October 30, 2020

Re: Sudbury-Hudson Transmission Reliability and Mass Central Rail Trail Project

On behalf of NSTAR Electric Company d/b/a Eversource Energy ("Eversource"), VHB is providing supplemental information in response to the requests for additional information dated September 24, 2020, and October 15, 2020, from the Sudbury Historical Commission. Requests made in the letters are set in bold and italic below, and responses are provided in plain text.

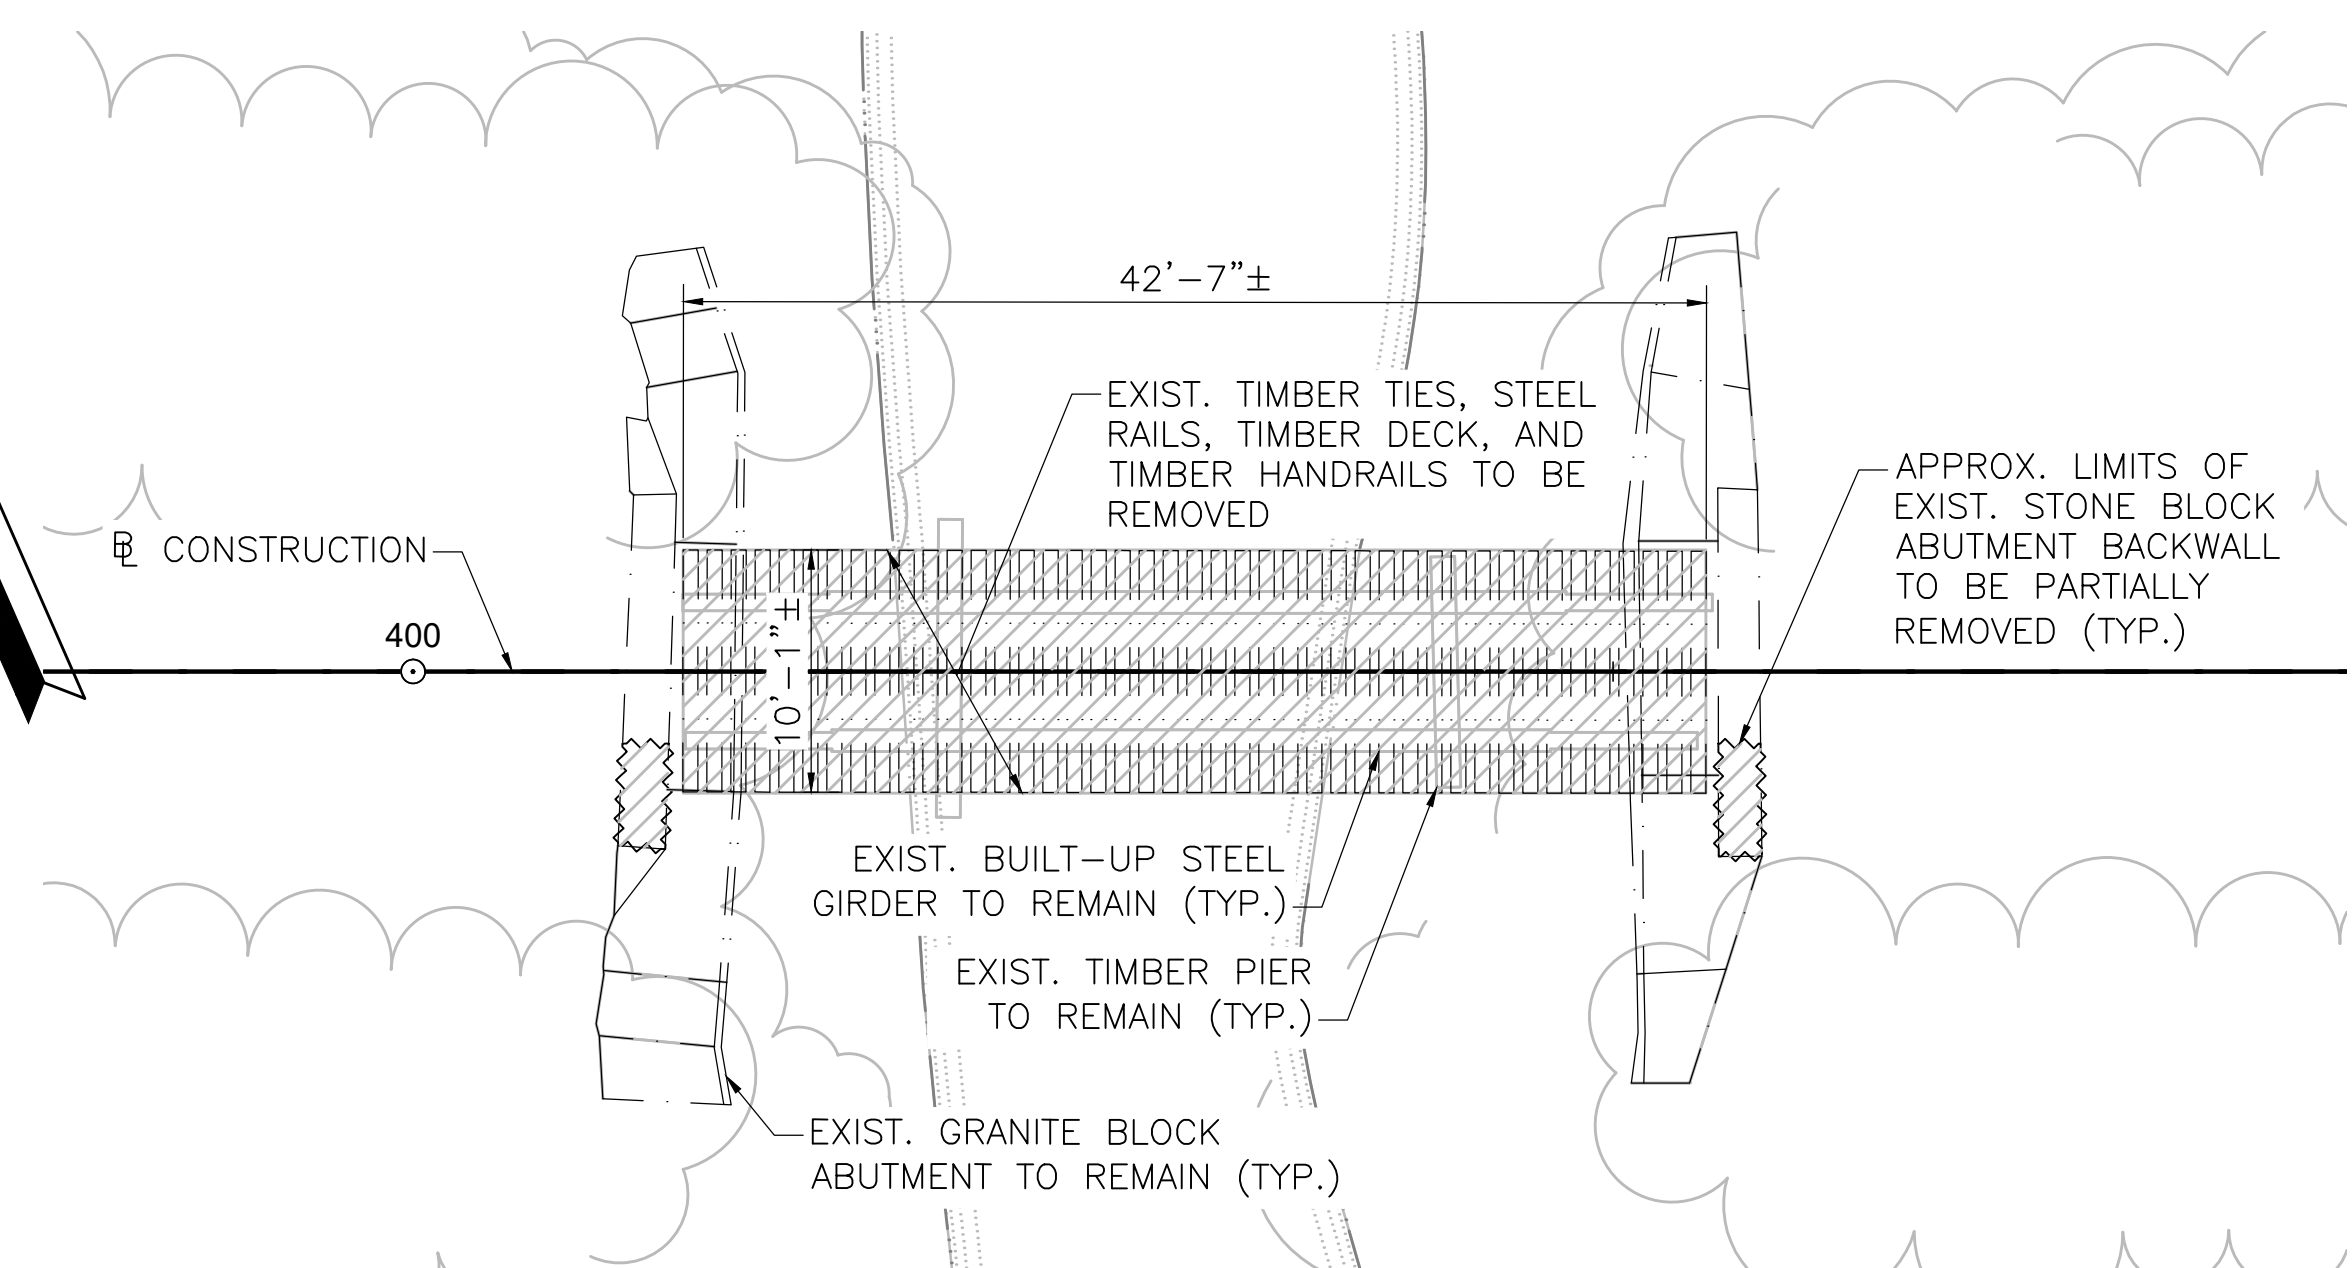
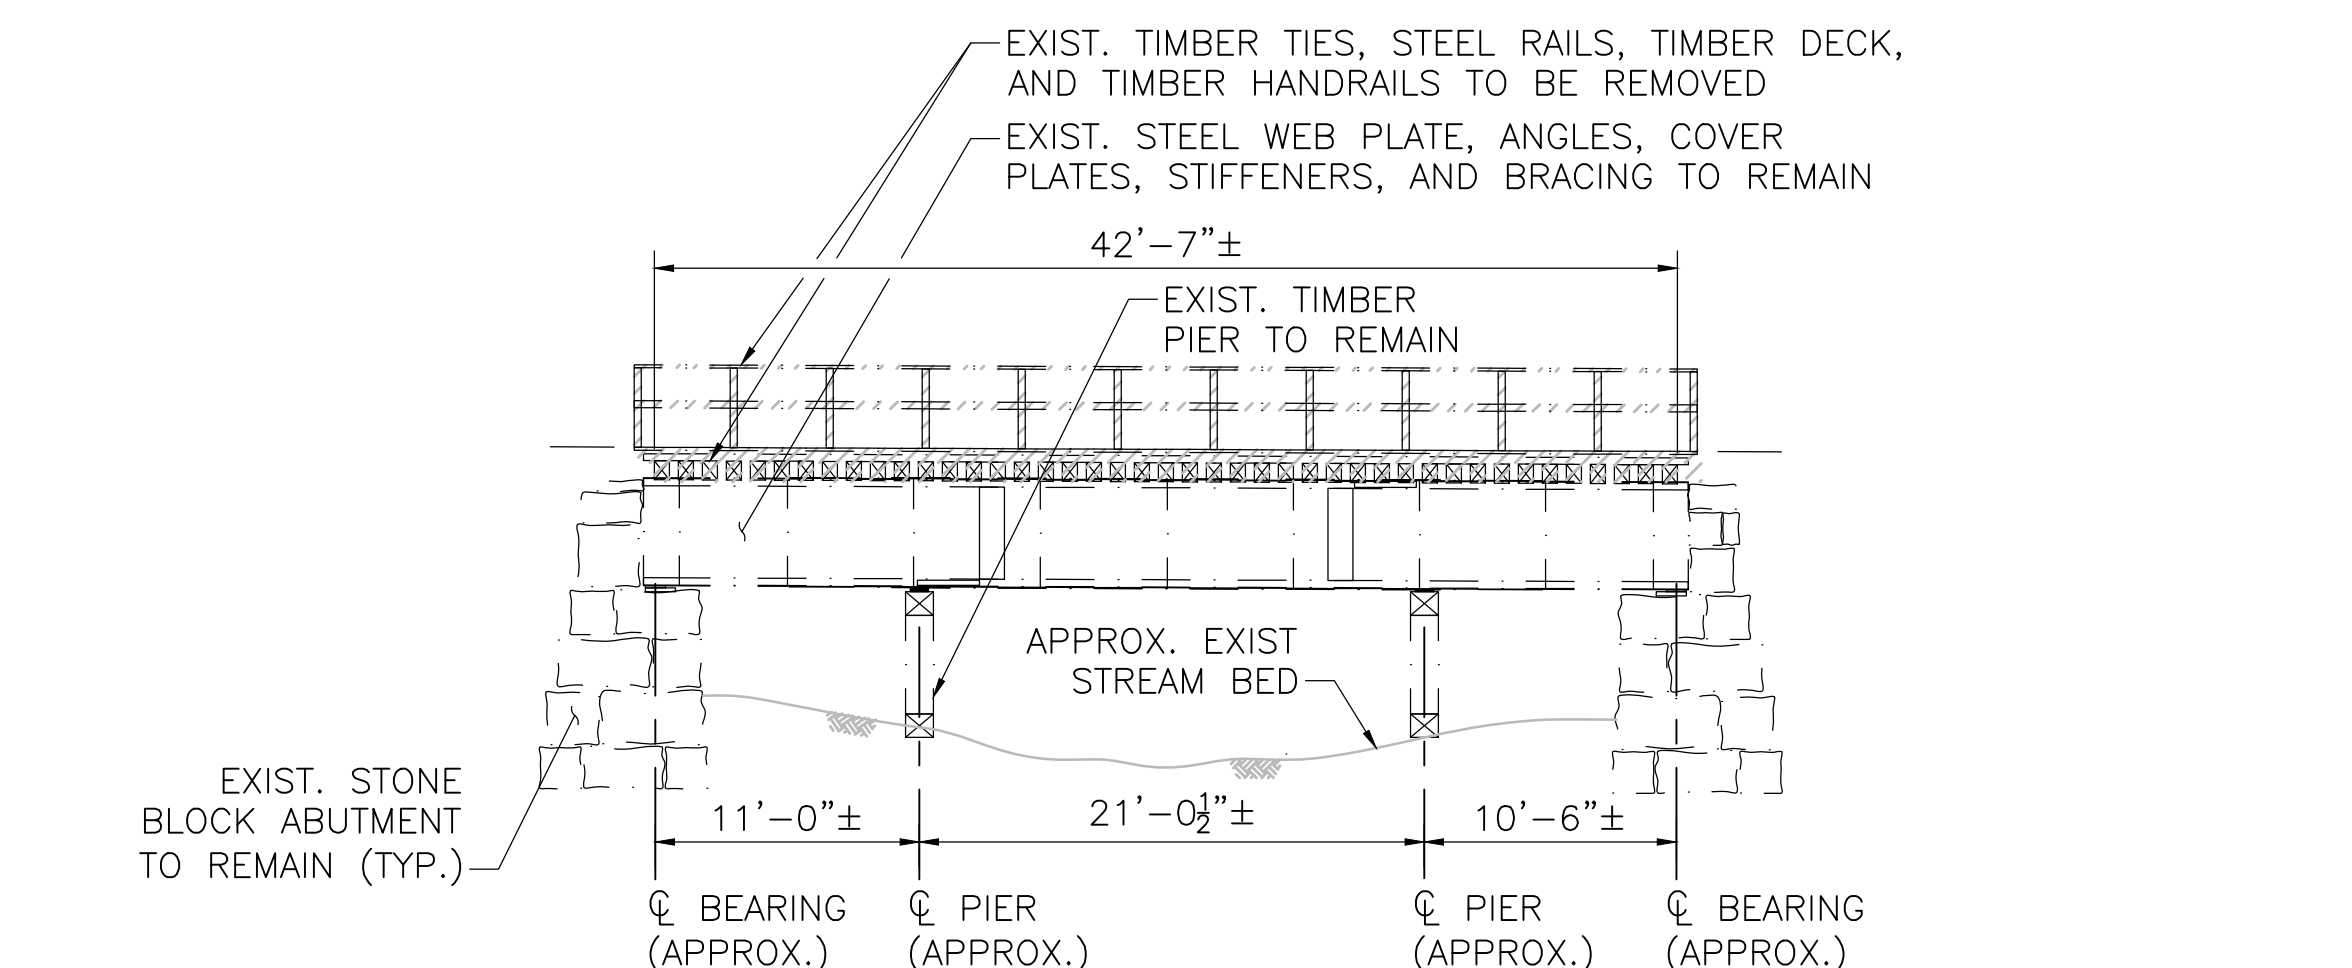
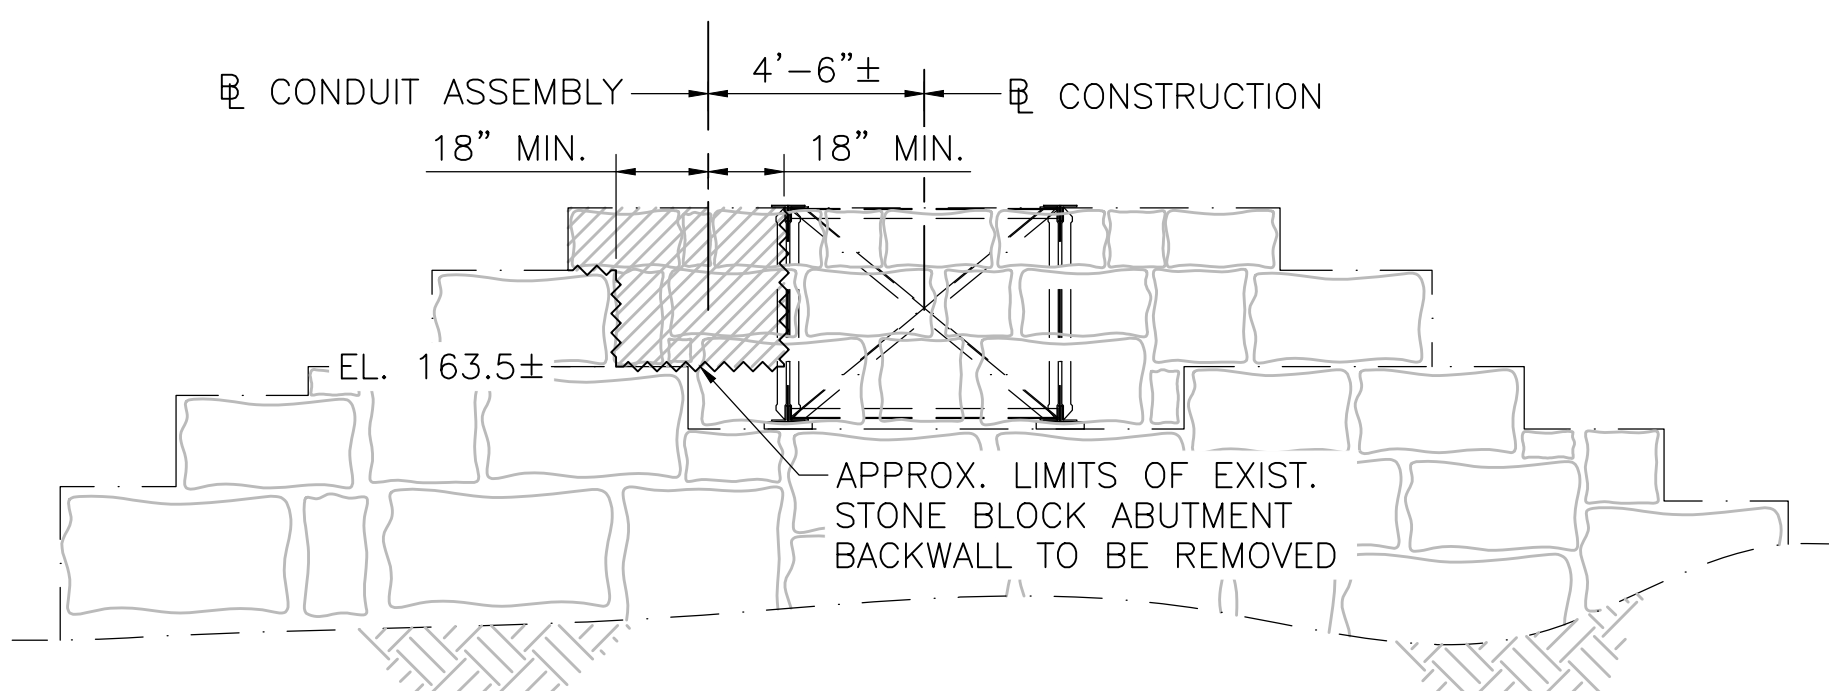
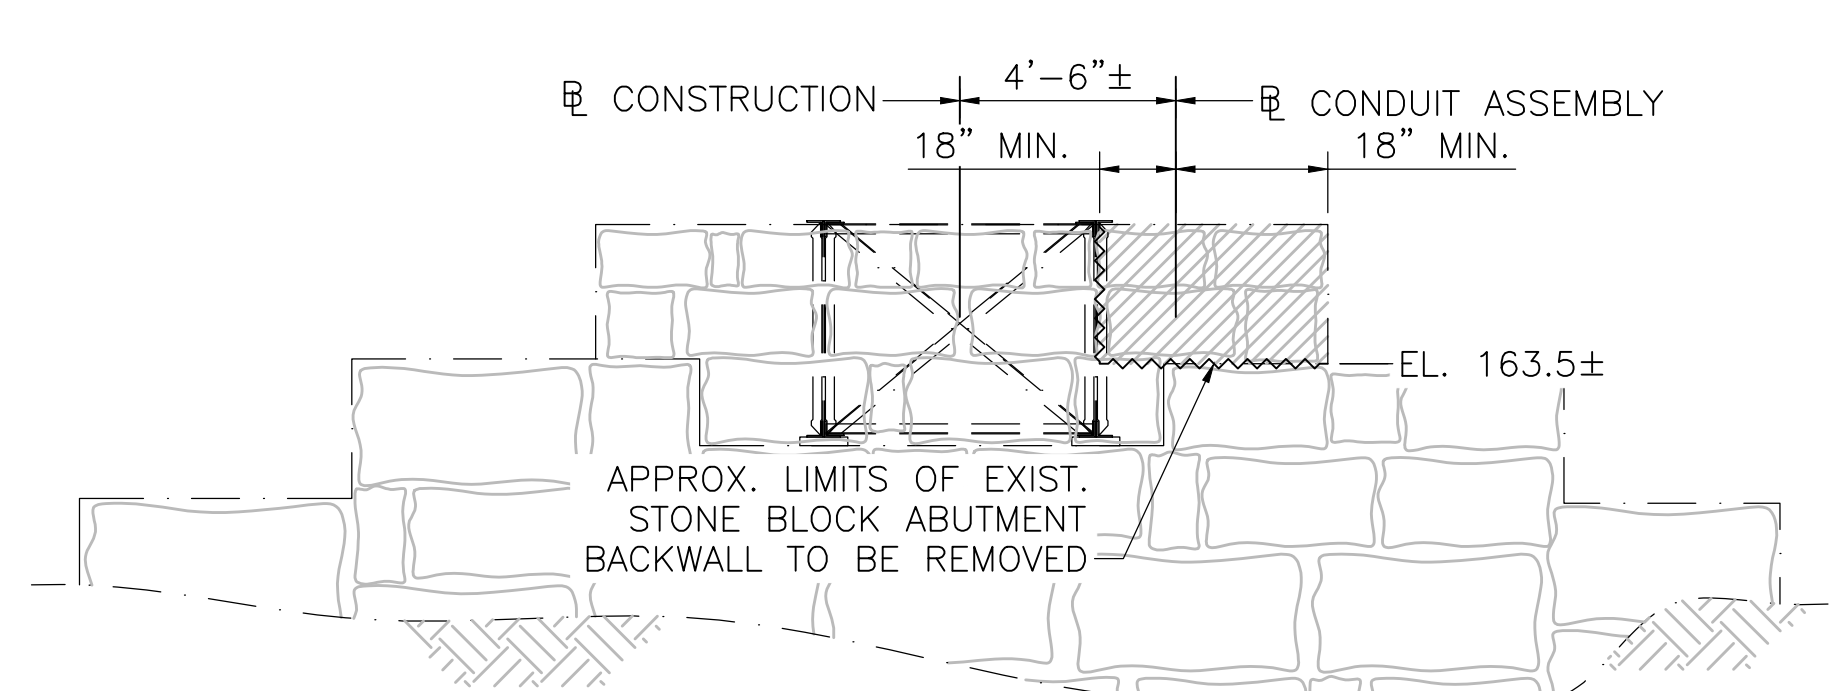
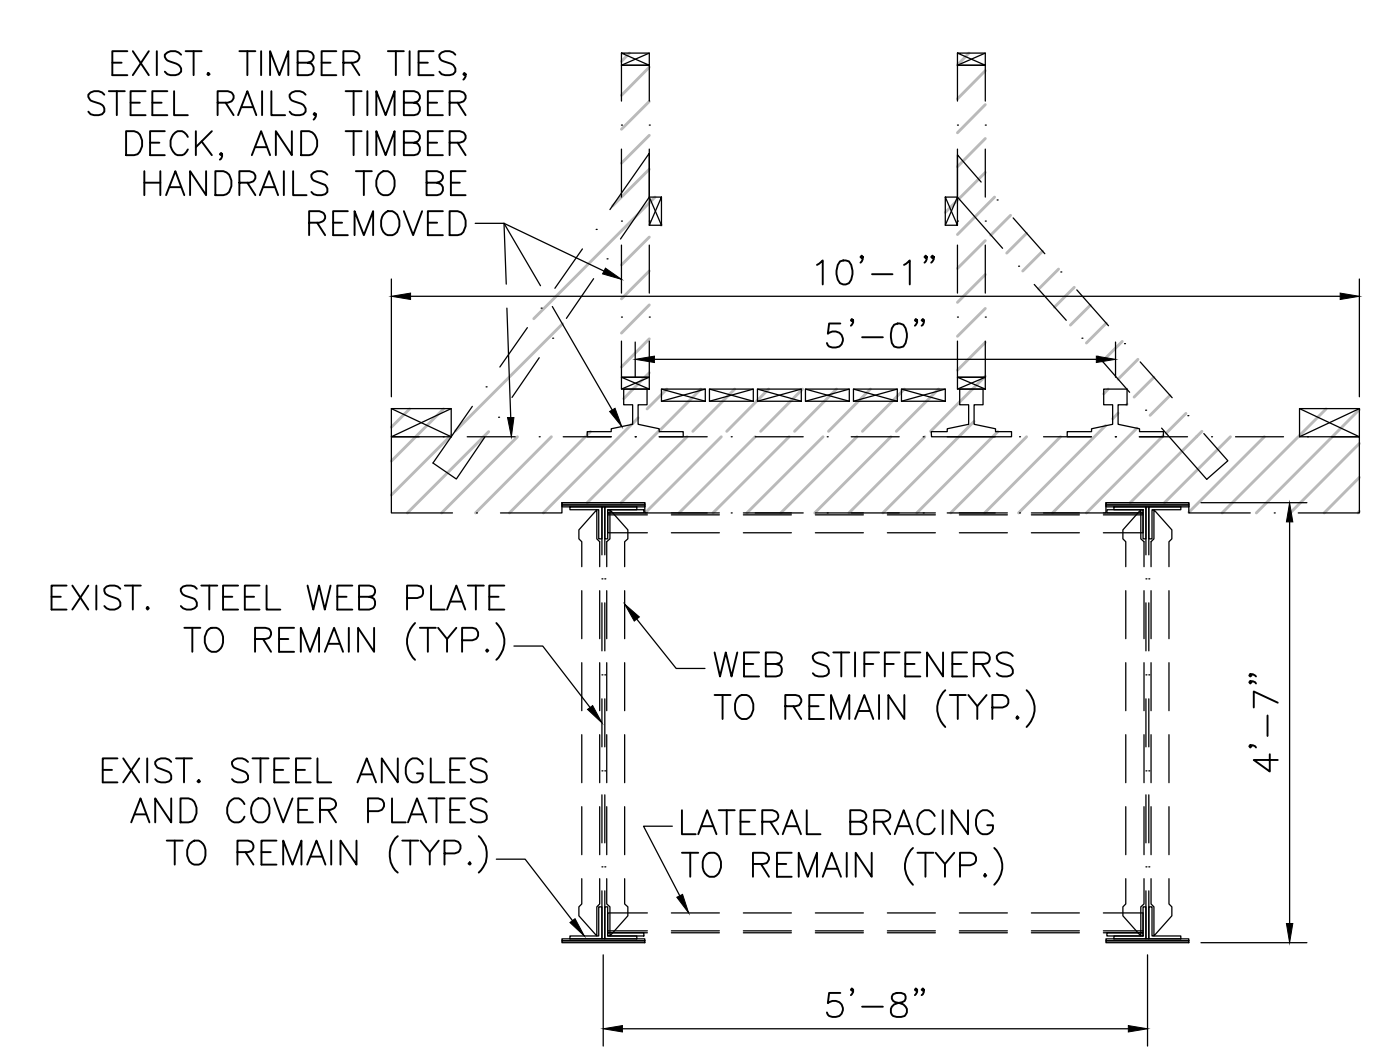
Clarify which granite embankment abutment blocks will be removed on Hop Brook Bridge #127 and #128 on a photo rendering with descriptions.

As shown on the previously provided photo renderings, at Bridge 127 the top two courses of the existing stone block backwall will be removed, and at Bridge 128 approximately 18" of the existing stone block backwall will be partially removed. In addition, the areas to be removed are shown on the attached plan sheets for both bridges.

Approx. 18" of stone block backwall to be partially removed

Approx. 18" of stone backwall to be removed
